## PLAT COMMITTEE

<b>Case Number:</b>	2023-PLT-046
<b>Property Address:</b>	2251 Sloan Avenue ( <i>Approximate Address</i> )
<b>Location:</b>	Center Township, Council District # 21
<b>Petitioner:</b>	City of Indianapolis Board of School Commissioners, by Michael Kalberg
<b>Zoning:</b>	SU-2 (FF) (FW)
<b>Request:</b>	Approval of a Subdivision Plat, to be known as Paul I. Miller IPS School 114, dividing 17.065 acres into two lots.
<b>Waiver Requested:</b>	None
<b>Current Land Use:</b>	School
<b>Staff Reviewer:</b>	Allison Richardson, Senior Planner

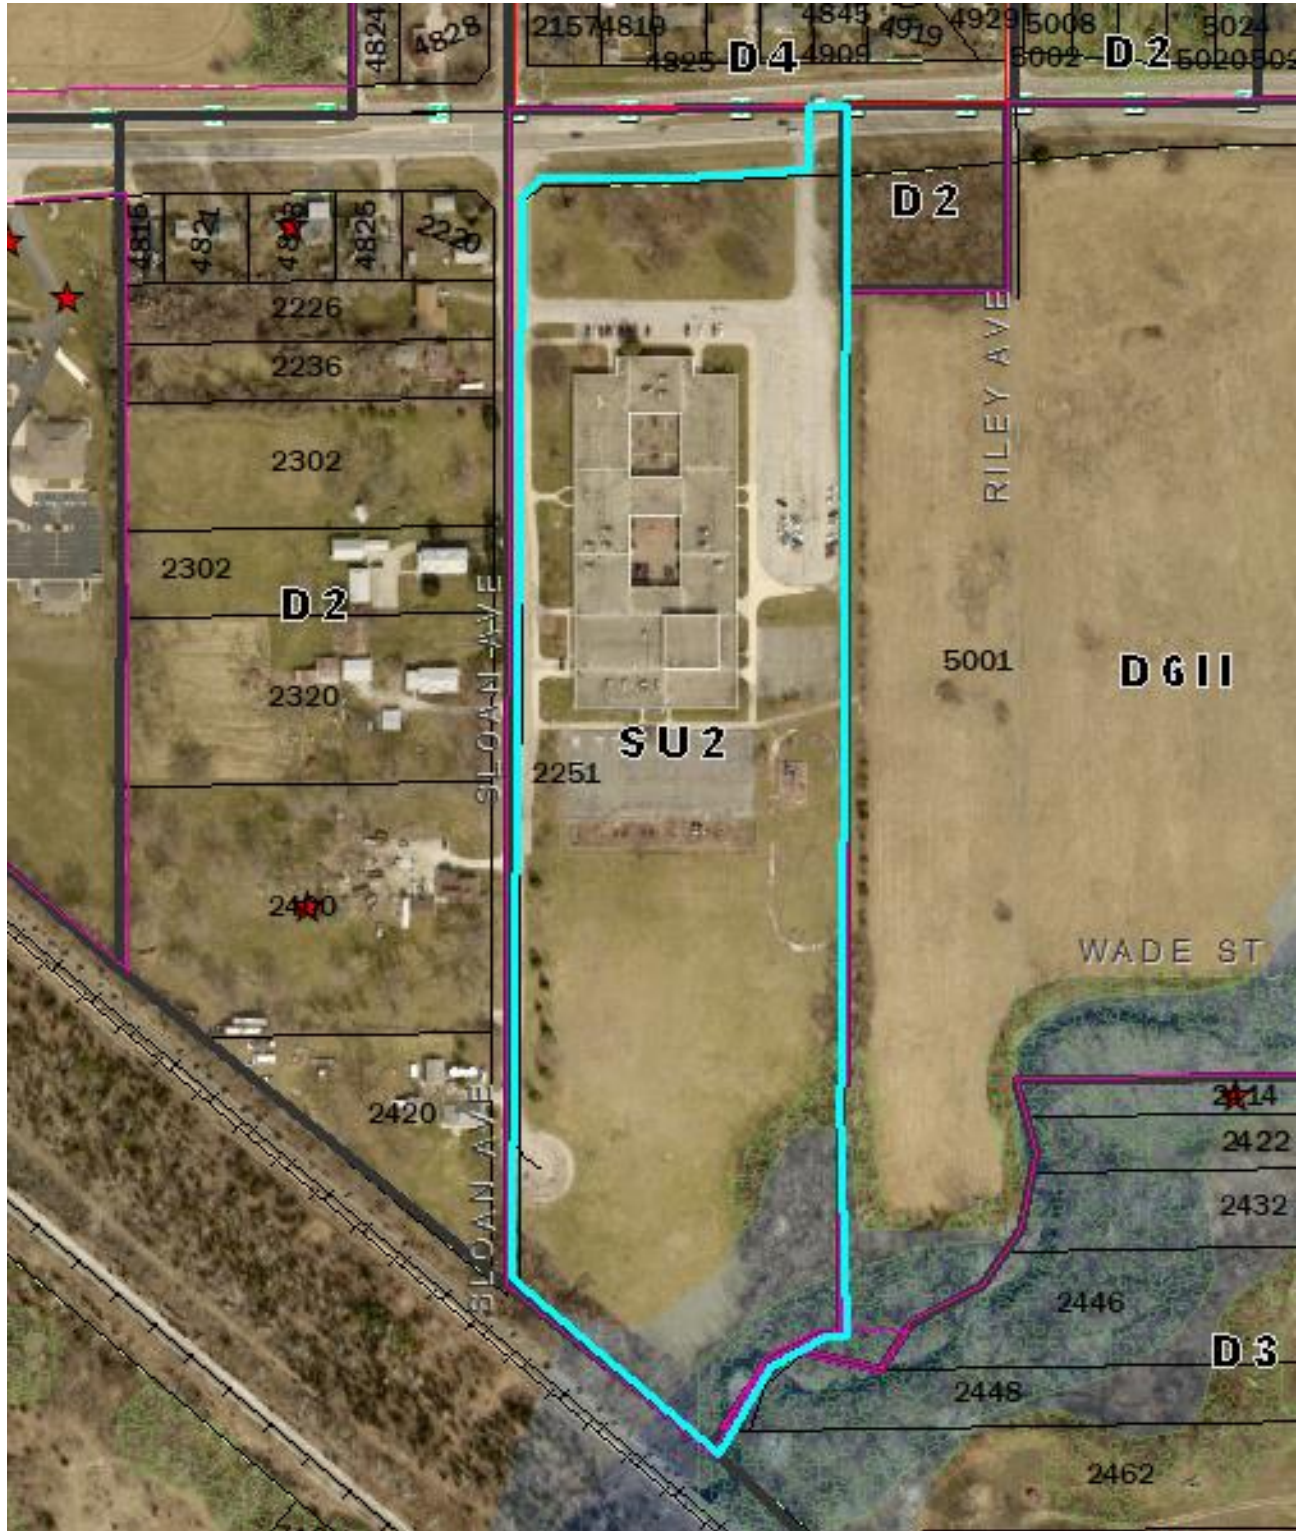
Lot One and Two would front on Sloan Avenue. Lot One would be a corner lot with frontage on Raymond Street.

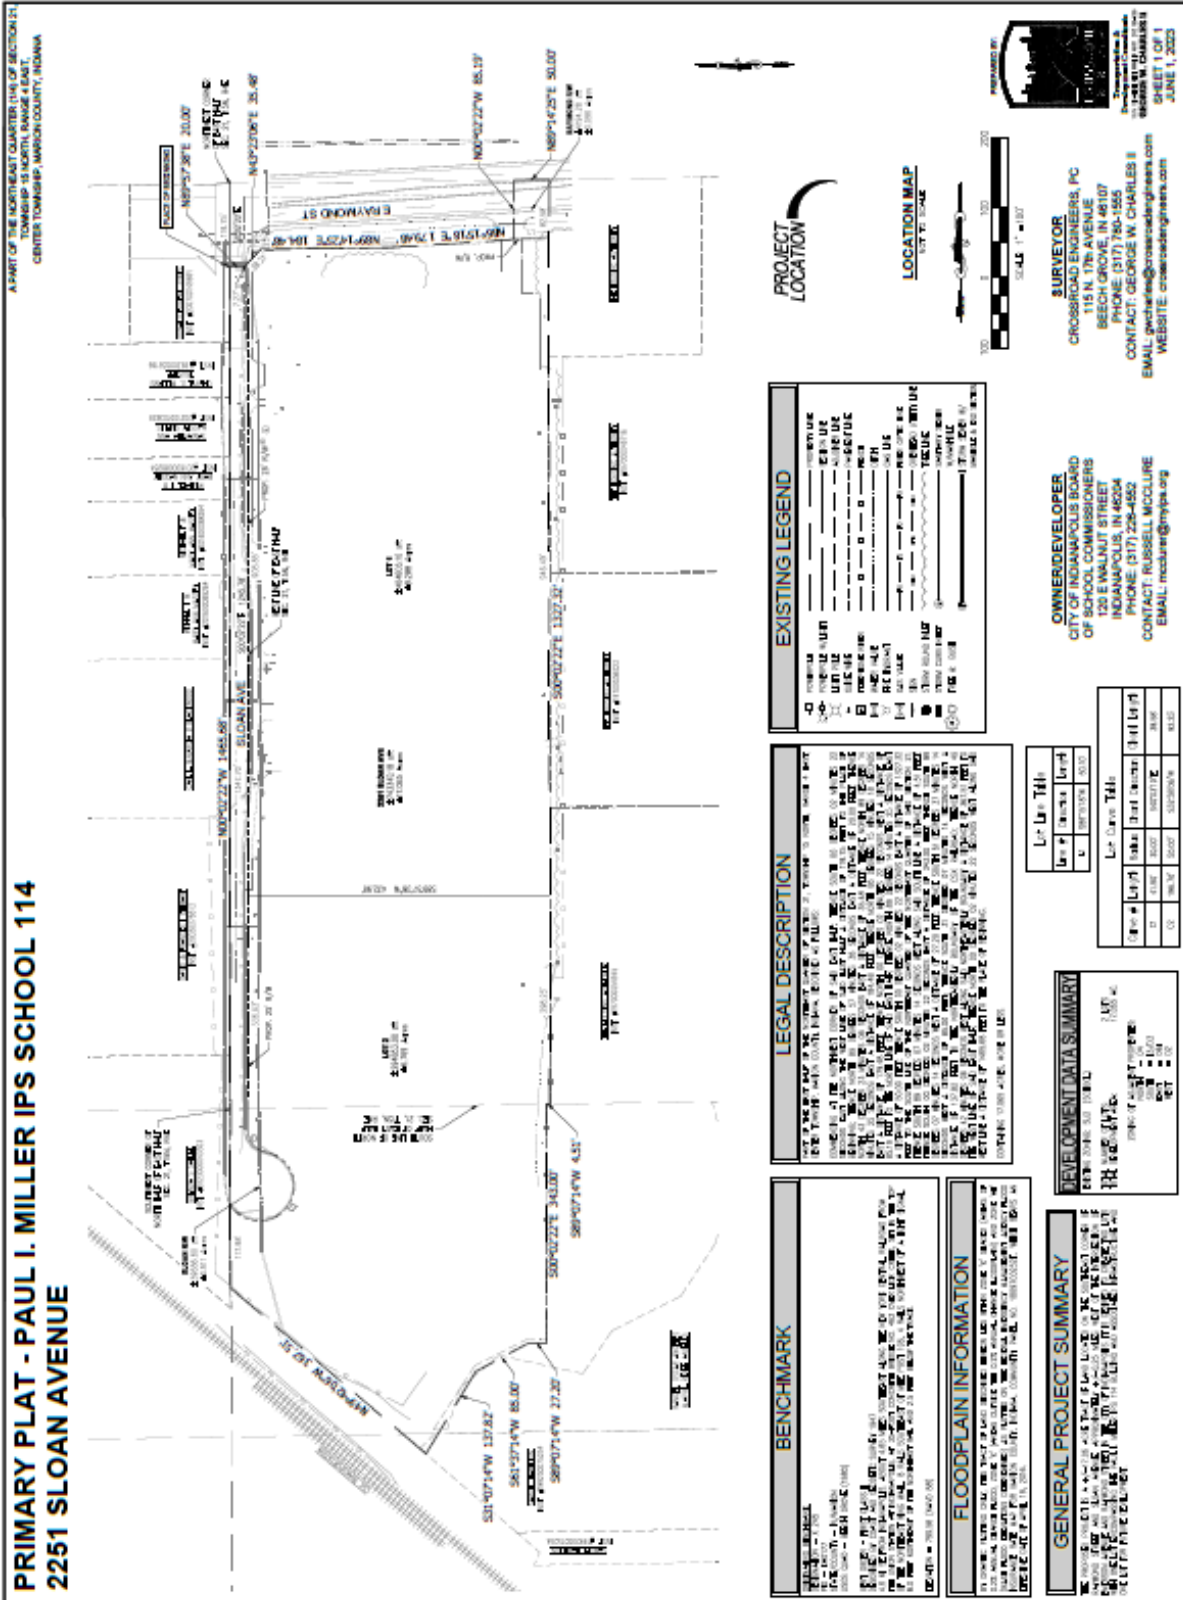
Sidewalks are required on Sloan Avenue. Sidewalks are existing on Raymond Street.
